E4446A-05A

S E R V I C E N O T E

PSA Series Spectrum Analyzer

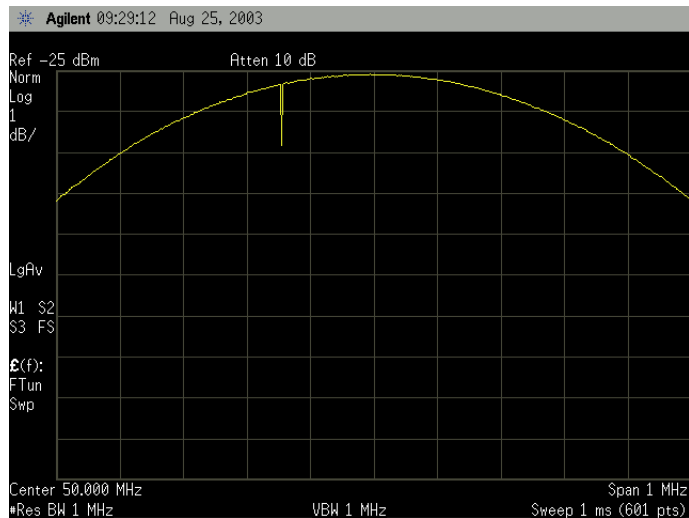
- Press the PRESET key.
- Tune the instrument to 50 MHz by pressing the FREQUENCY key followed by 50 MHz.
- Set the span to 1 MHz Hertz by pressing the SPAN key followed by 1 MHz.
- Set the Resolution Bandwidth to 1 MHz by pressing the BW/AVG and setting the Res BW to 1 MHz.
- Turn the 50 MHz calibration signal on by pressing the INPUT/OUTPUT key and selecting the Input Port to be the 50 MHz Amplitude Reference.
- Set the Reference level to -25 dBm and the Scale/Div to 1 dB by pressing the Amplitude key.

Effected instruments will randomly show an amplitude drop of approximately 2 to 3 dB.

Replace the A7 Digital IF assembly P/N E4440-60025 or E4440-60195 with the Digital IF exchange assembly P/N E4440-69195. Perform recommended performance verification procedures and possible adjustments. Please reference the PSA Service guide for additional details.
